**Southern
Water**

Your ref
FP/185/19/PL

Proposal: Detached dwelling - Resubmission of FP/201/18/PL.

Site: FP/185/19/PL: - Mermaid and Playbox, Sea Road, Felpham, PO22 7AW.

ARUN DISTRICT COUNCIL FP/185/19/PL

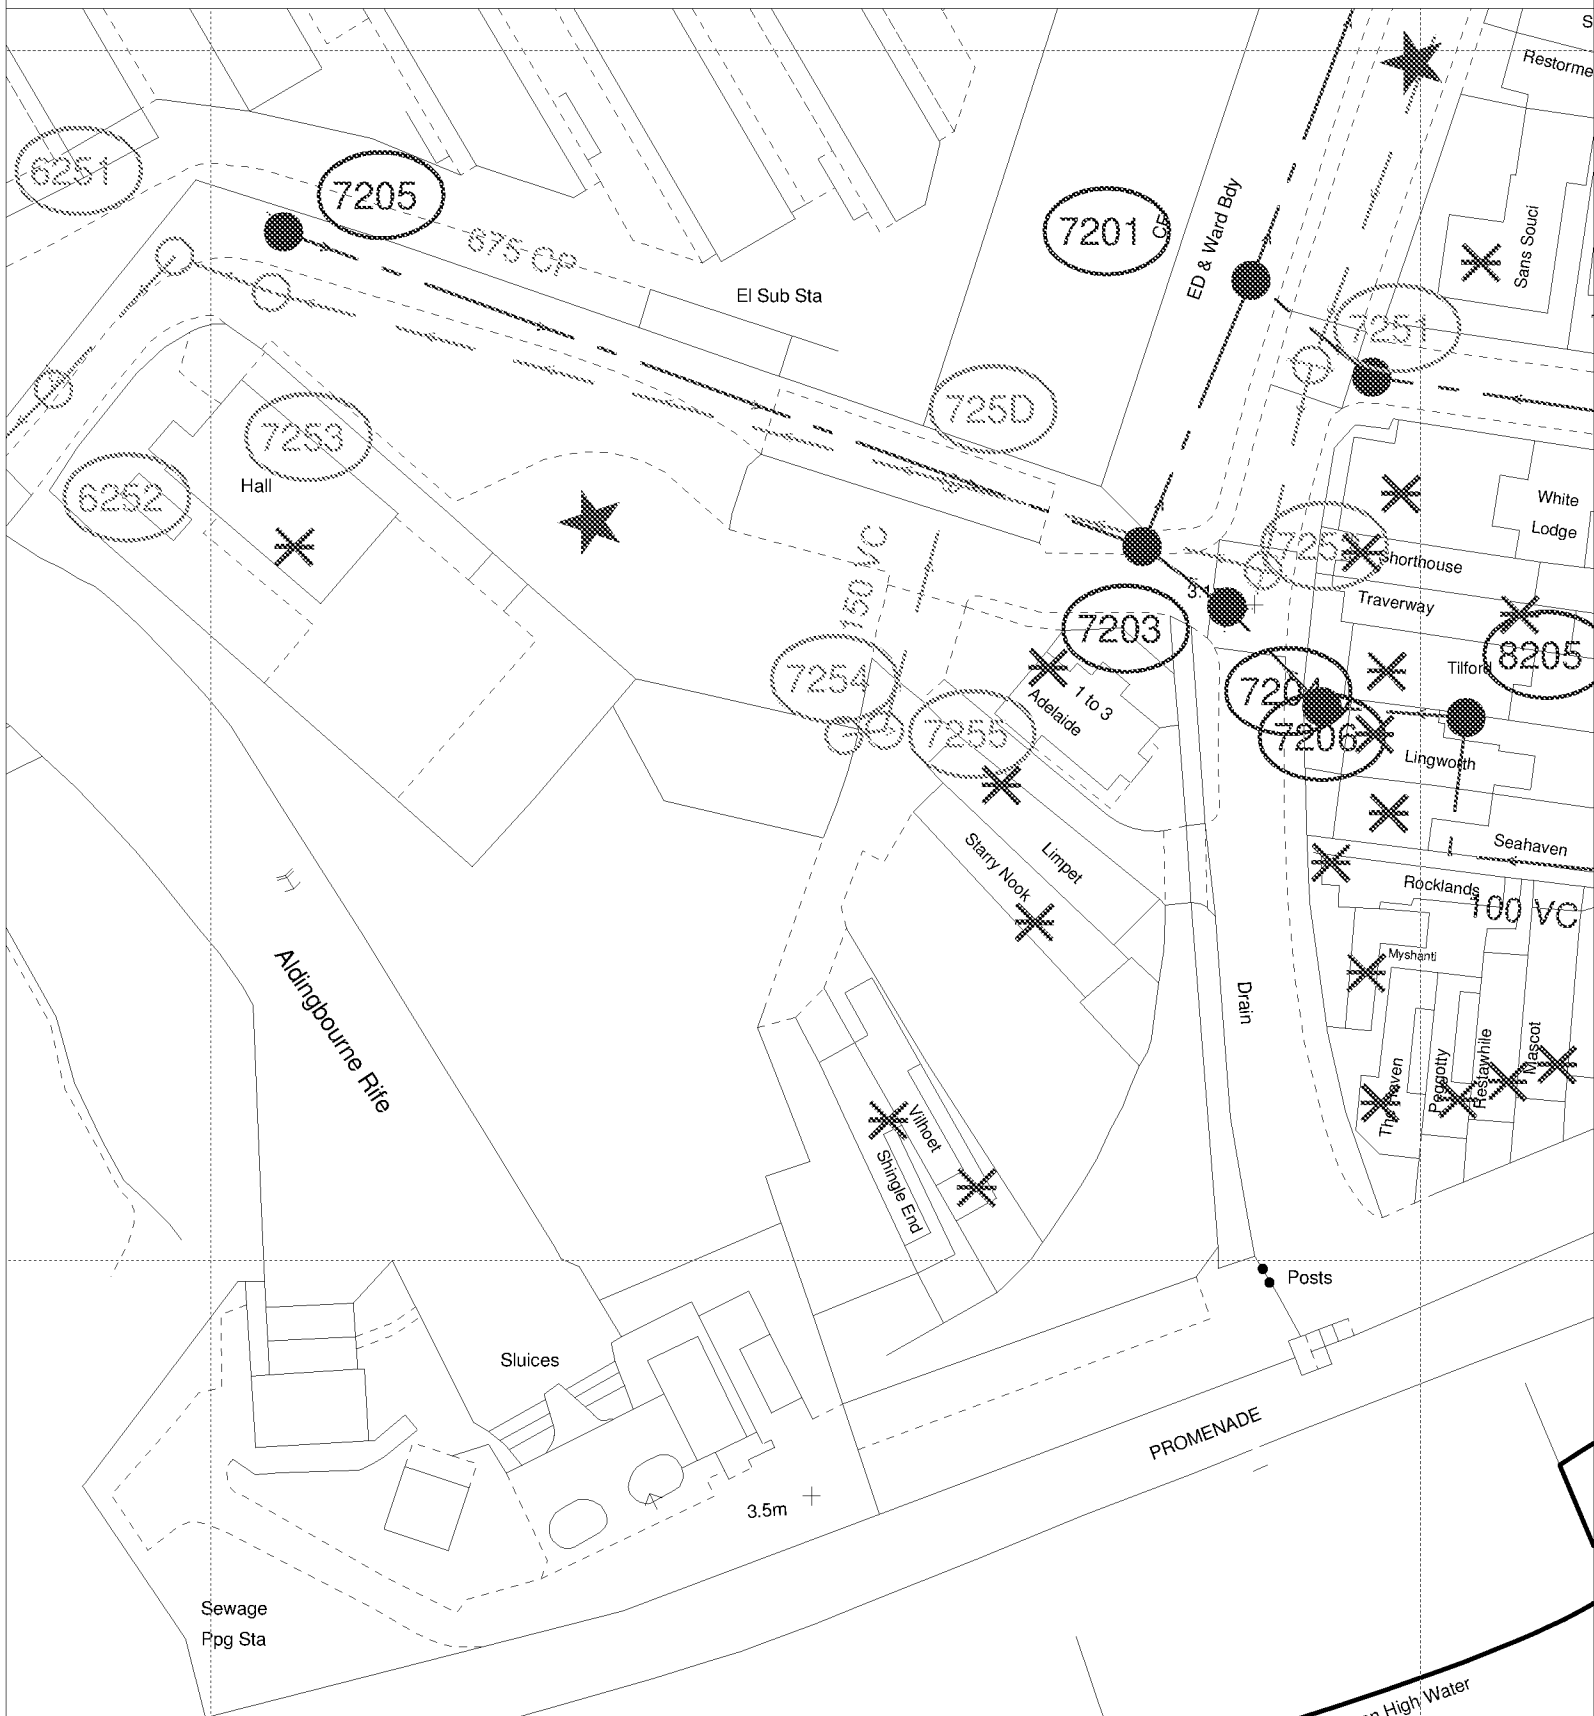
Please find attached a plan of the sewer records showing the approximate position of a public surface water sewer within the site. The exact position of the public sewers must be determined on site by the applicant before the layout of the proposed development is finalised.

- The 150 mm diameter surface water sewers require a clearance of 3 metres on either side of the gravity sewers to protect it from construction works and to allow for future access for maintenance.
- No development or tree planting should be carried out within 3 metres of the external edge of the public gravity sewer without consent from Southern Water.
- No soakaways, swales, ponds, watercourses or any other surface water retaining or conveying features should be located within 5 metres of a public sewers.
- All existing infrastructure should be protected during the course of construction works.

Furthermore, it is possible that a sewer now deemed to be public could be crossing the development site. Therefore, should any sewer be found during construction works, an investigation of the sewer will be required to ascertain its ownership before any further works commence on site.
